From: Mark Simmons <Mark.Simmons@north-herts.gov.uk>
Sent: 13 September 2024 17:18:08 UTC+01:00
To: "Melissa Tyler" <Melissa.Tyler@north-herts.gov.uk>
Subject: 6 Hitchin Street, Baldock, Hertfordshire SG7 6AE (24/01894/DOC)
Importance: High

Details reserved by Condition 4 (Windows and doors) of Listed Building Consent reference 19/01929/LBC granted on 17.11.2021

Item: 11	FLUSH CASEMENT WINDOW IN FINGER JOI
Style: DL1	Item Reference: Bedroom 5 Ensuite
Key Features:

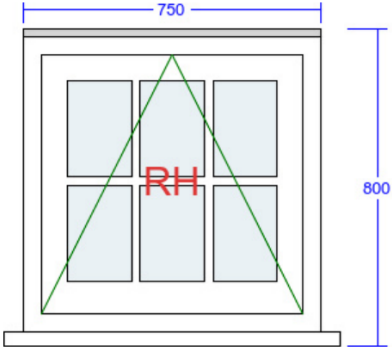
The window in the photo below appears to be the one intended to be Item 11 of the Timber Windows of St Albans quote and looks acceptable.

We not, however, have images for all the windows but based on the details provided it all seems ok. This only becomes an issue if the windows do not meet either spec in the condition.

Considering that the windows are confirmed as being externally putty glazed, it is assumed that the images below are of the internal glazing bar profile.
